Connah's Quay Low Carbon Power

Targeted consultation on changes to our proposals

Thursday 8 May to Friday 6 June 2025

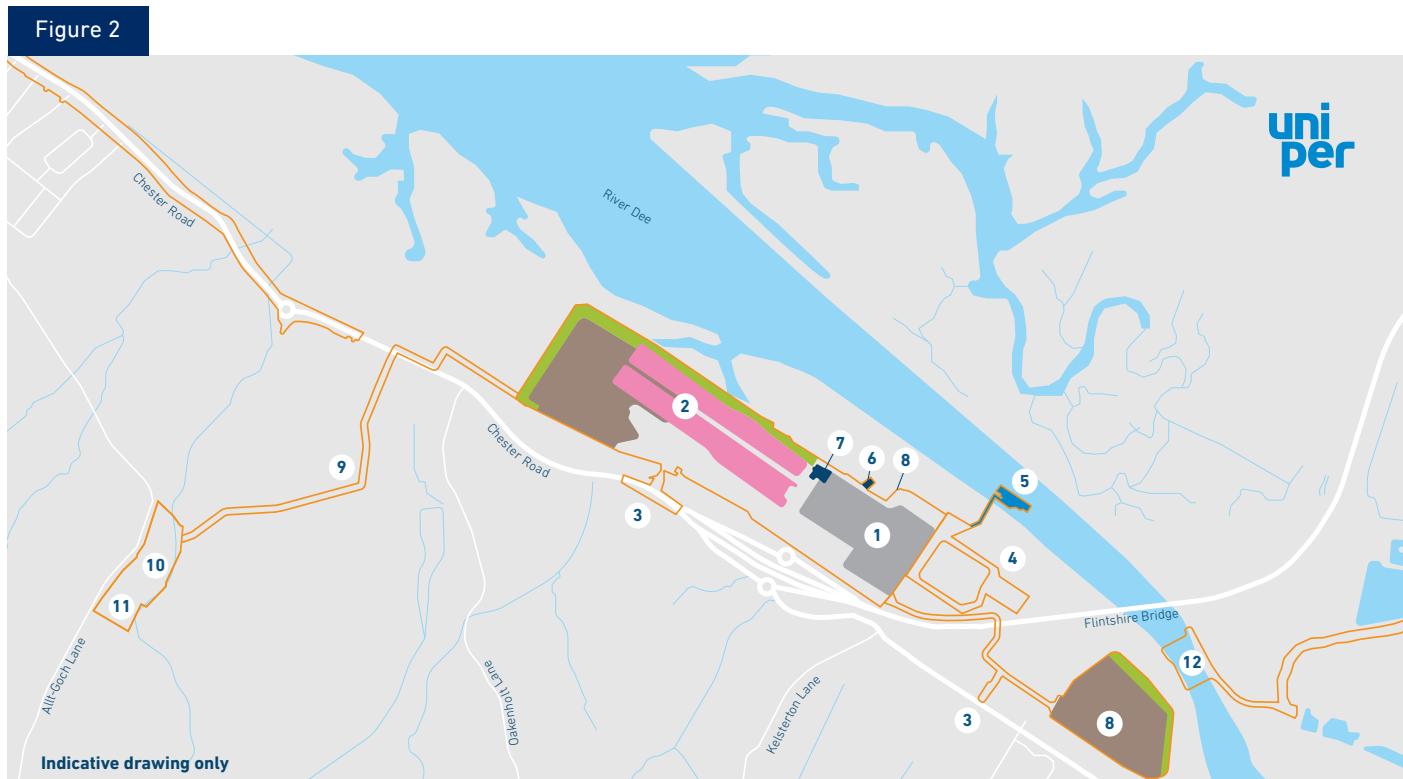
1. CHANGE: The project is proposed to be comprised of two CCGT generating plants each fitted with a CCP. These units and the supporting development required to operate them are referred to as 'Trains'. Initially, we were exploring the option to build two CCP per Train but this has now been removed in favour of a single CCP per Train.

3. CHANGE: The Proposed CO₂ Above Ground Installation (AGI) has been relocated within the Main Development Area.

5. CHANGE: We have increased temporary construction laydown area boundaries within the Main Development Area. This laydown area will include land previously assigned for the location of the proposed CO₂ AGI.

6. CHANGE: We have confirmed the location of the temporary compound within the Proposed CO₂ Connection Corridor.

7. CHANGE: We have included additional Maintenance Laydown Areas within the updated indicative design.

Figure 2 shows the updated indicative locations of key infrastructure for the proposed CQLCP project. Please note that these plans are still in an early stage of development and are subject to change following ongoing engagement with statutory bodies, local authorities and the local community. The final design will be determined during the FEED process, which commenced at the end of December 2024 and is expected to take around a year to complete.
